Project: **CAMPDEN HILL RESERVOIR**

MINOR AMENDMENTS TO FENESTRATION, HOUSES, CAMPDEN HILL RESERVOIR.

**Town & Country Planning Act 1990
Campden Hill Reservoir Site**

FANLIGHTS
OMITTED

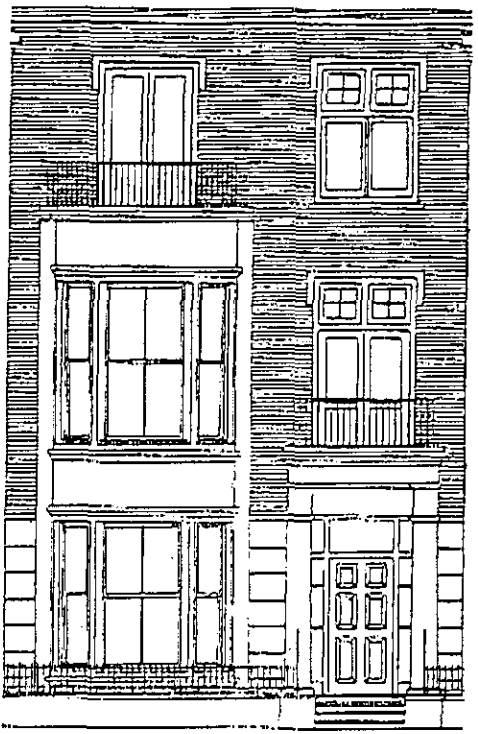
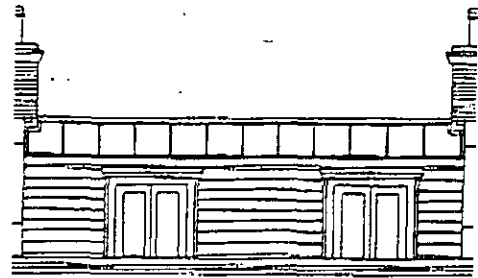
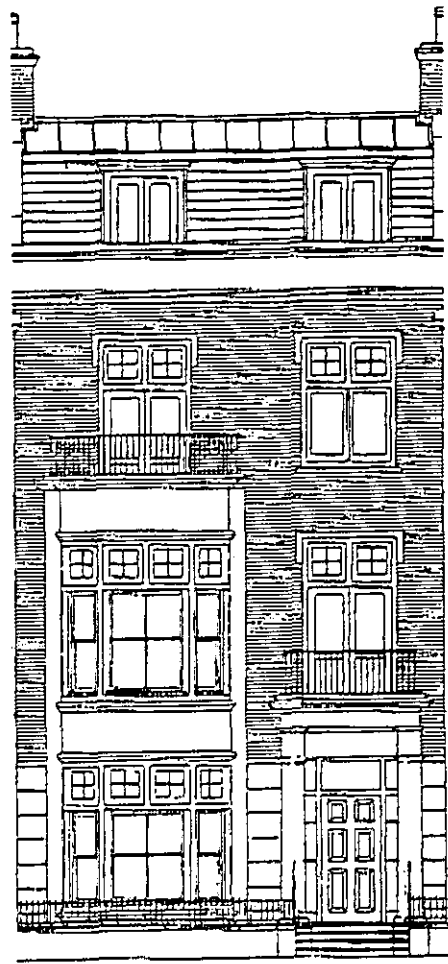
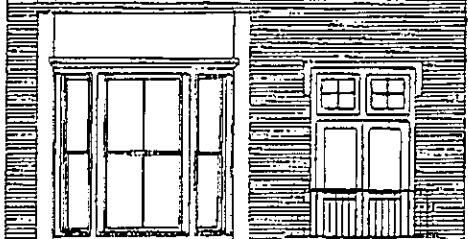
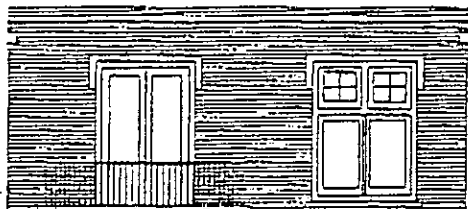
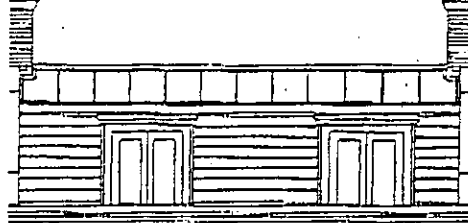
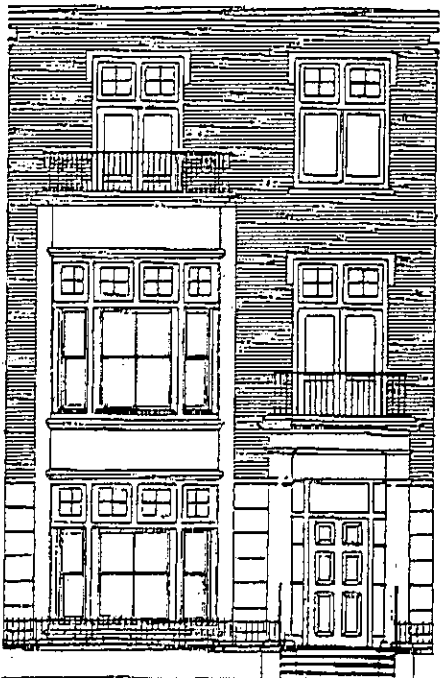
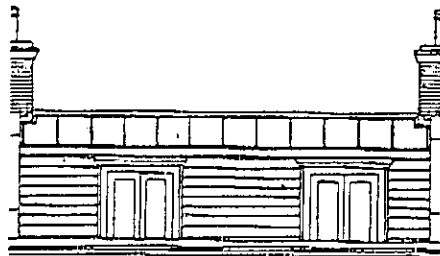
Further to our conversation this morning, please find attached two front elevation drawings for a typical terraced house at the above, one as permitted and one marked-up to show the design adjustments that we wish to make.

Principally these concern the omission of the 'fanlight' windows over bay windows and balcony doors, this elongates the proportions of the facade making it more elegant, which we consider to be a design improvement.

As discussed, the changes involve the omission of fanlights above the curved bay windows and balcony doors, giving the fenestration a more elongated, elegant proportion.

I can confirm that the omission of the fanlights above the curved bay windows and balcony doors as shown on your drawing numbers P103F, P104E, P105E, P108F, and P109E can be treated as a non material amendment to the scheme granted planning permission on 14 October 1999.
